DA NO: DA-2021/6/A

ADDRESS: 1 DORSET ROAD, NORTHBRIDGE NSW 2063.

PROPOSAL: MODIFY ORIGINAL PROPOSAL TO INCLUDE ALTERATIONS TO ENTRY LOBBY, LOWER GROUND AND CABANA, DELETION OF GYM, AND ADDITION OF DRAINAGE CAVITY TO BOATSHED AND ASSOCIATED WORKS.

REPORT DATE: 31 AUGUST 2023

Figure 4: Proposed entrance and garage floor plan

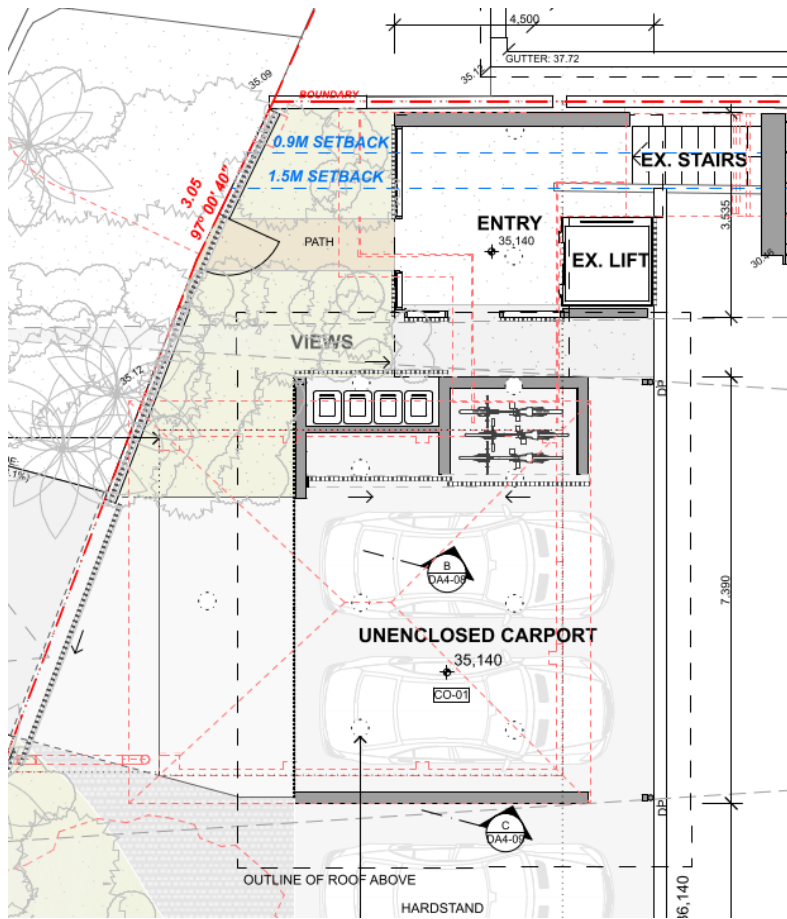
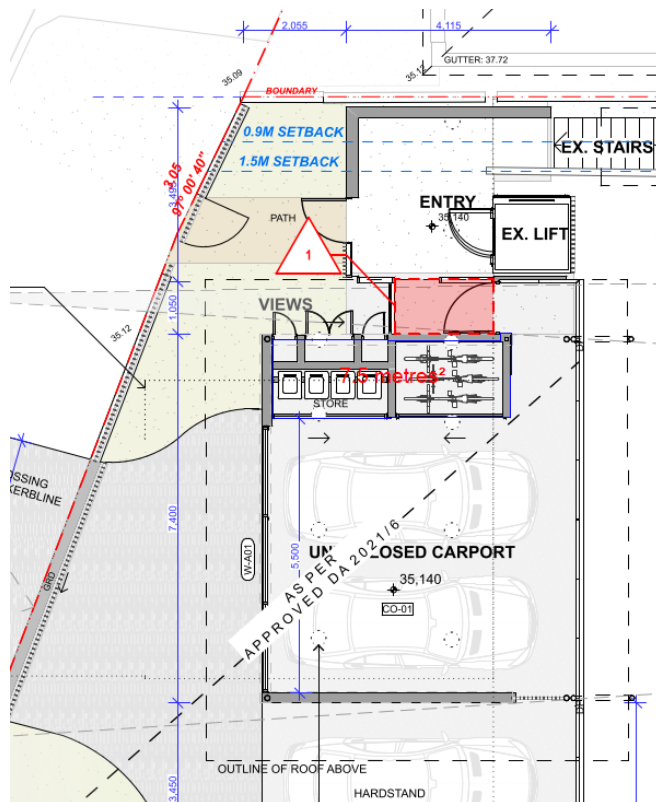
- Garage and entry:
 - o Enclosure of connection to street level entry lobby
 - o Change in materials including change from see through wooden battening to solid glass and block walls;
 - o Garage door wooden batten to panel door with $\frac{3}{4}$ see through panels.

Figure 8: Proposed ground floor plan

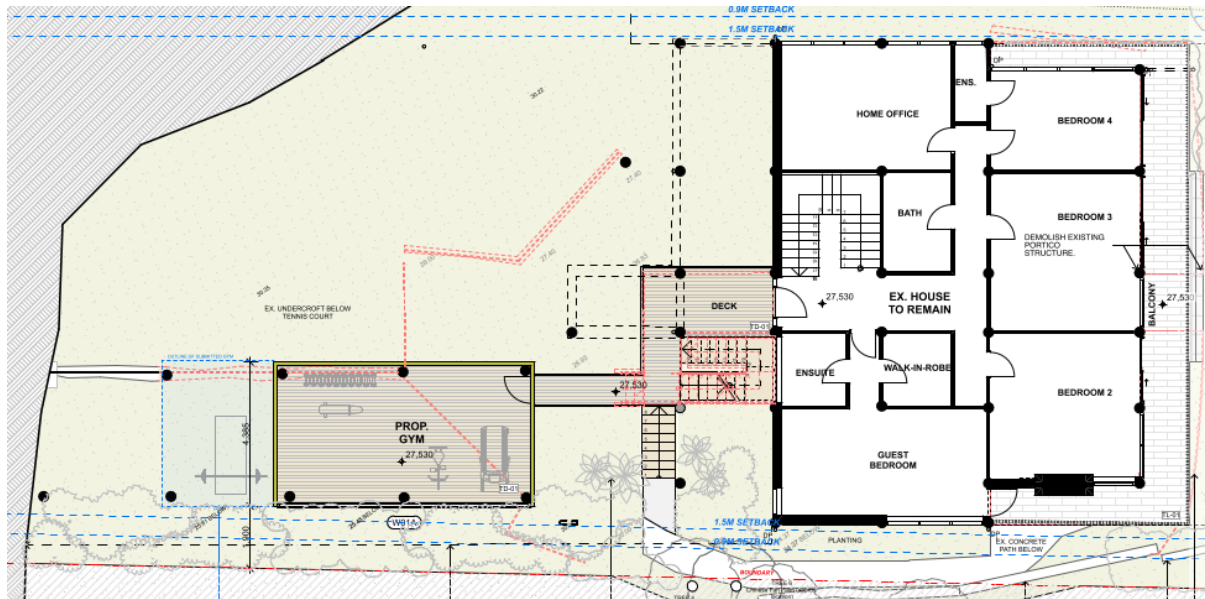
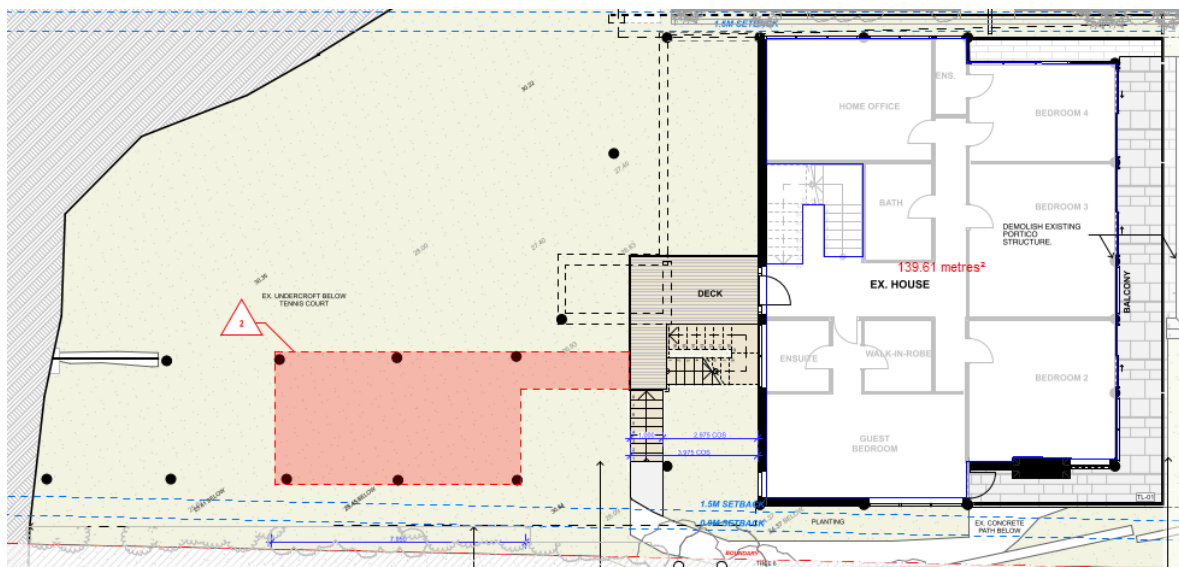
- Ground floor
 - o Removal the gym under tennis court;

Figure 10: Proposed lower ground floor plan

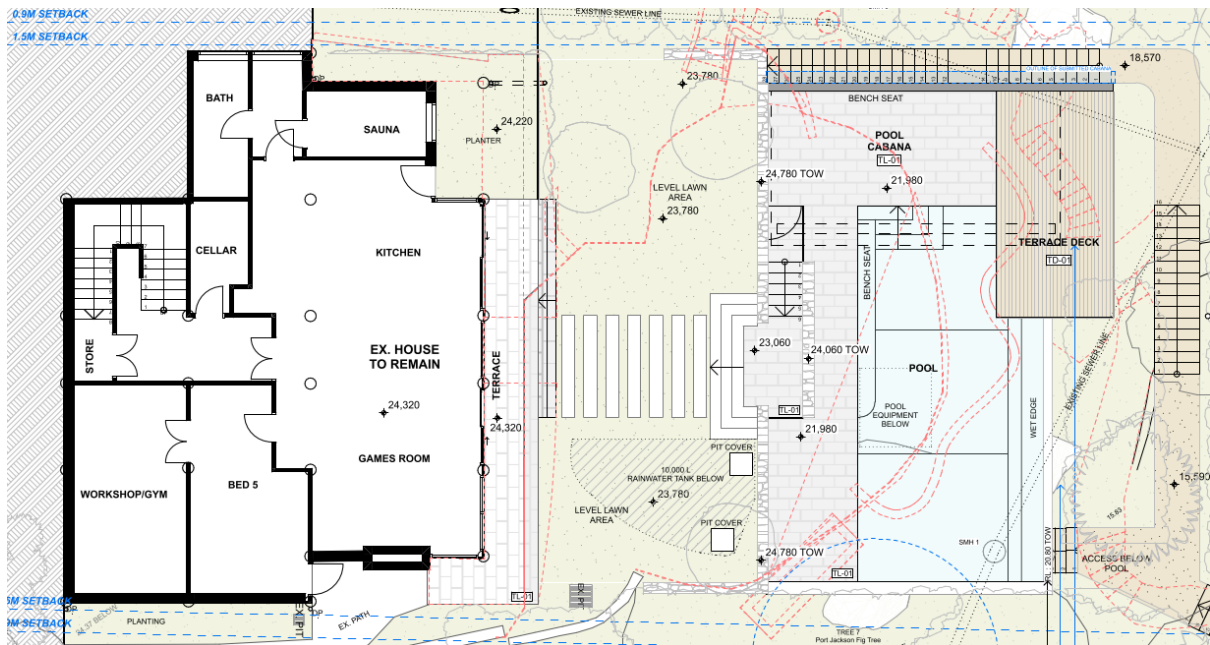
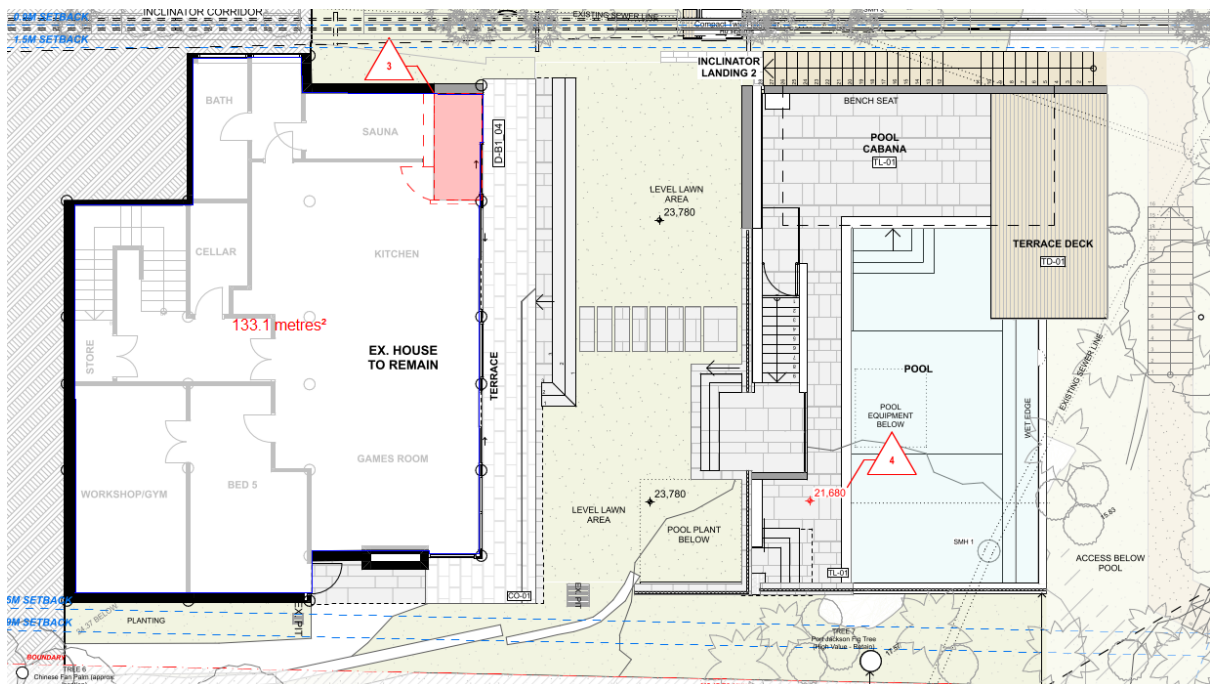
- Lower Ground Floor
 - o Minor additional floor area added to the lower ground of the existing house;
 - o Extension of terrace area;
 - o Cabana floor level lowered by 300mm;

Figure 12: Proposed boat shed

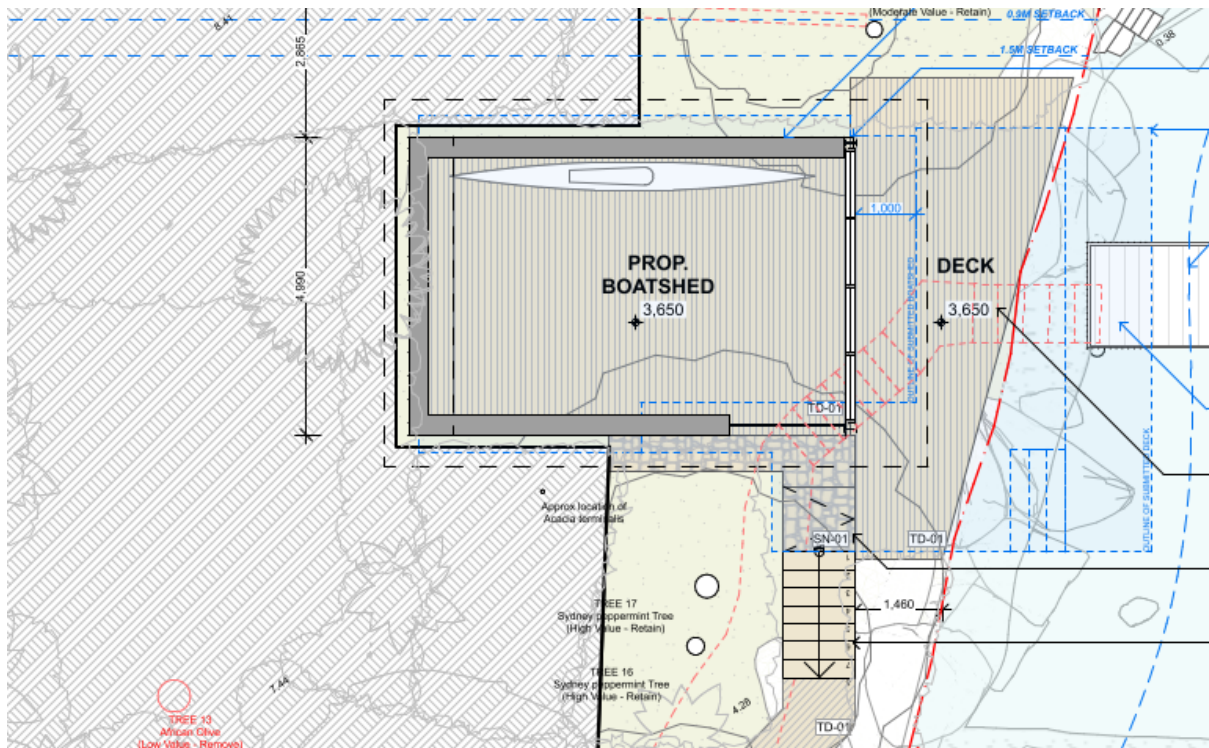
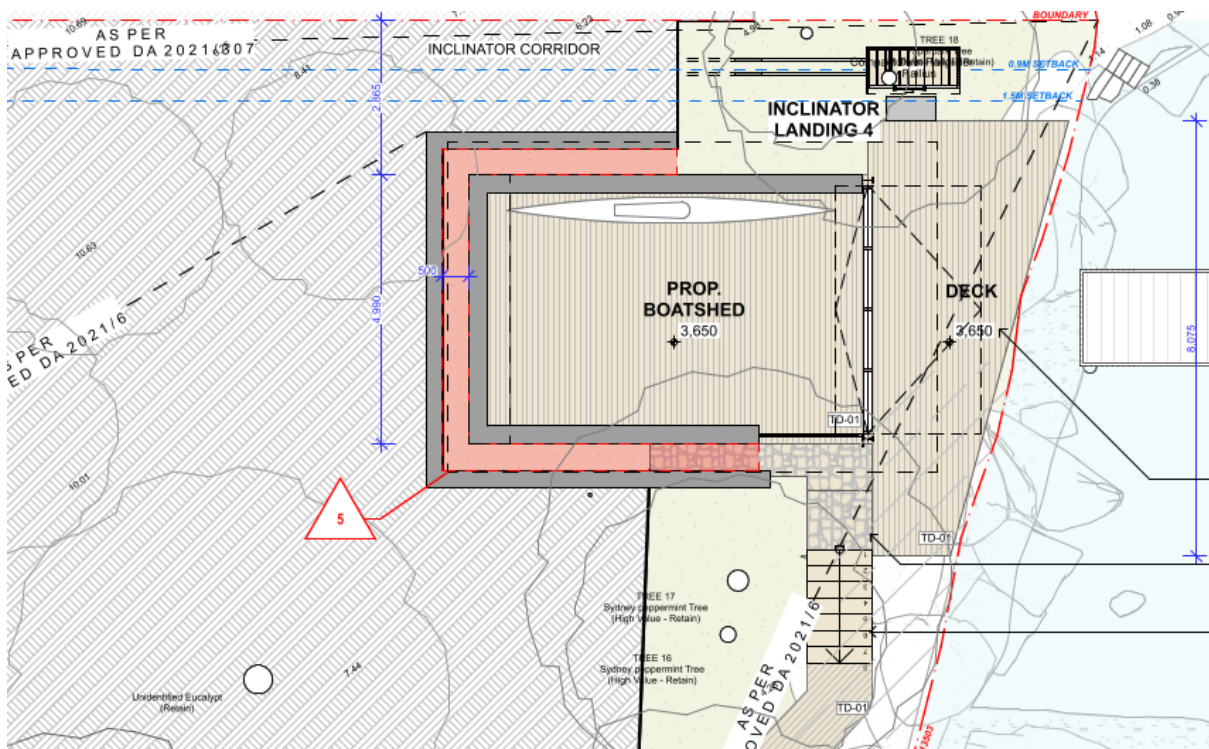
- Boat shed
 - o Additional 500mm excavation into site to allow for a drainage cavity supported by retaining wall.

Boat Shed	
"Expanded size of boathouse"	The boat shed structure does not change from the approved parent consent. The modification seeks addition excavation to accommodate a drainage void and associated retaining wall.
"Boat house is closer to 3A Dorset than"

Given the retaining wall for the boat shed drainage void and partial walls of the front entrance have already been constructed, a new condition will be imposed to require the owner to obtain a building information certificate and its approval for the works should the panel consider approval. Condition 76A reflects this requirement.

Prior to any Occupation Certificate, an application for a Building Information Certificate (BIC) must be lodged with Council and approved for the unauthorised drainage void excavation and retaining wall & front entrance enclosure on the subject premises, in accordance with Division 6.7 of the Environmental Planning & Assessment Act, 1979, to ensure compliance with the National Construction Code.
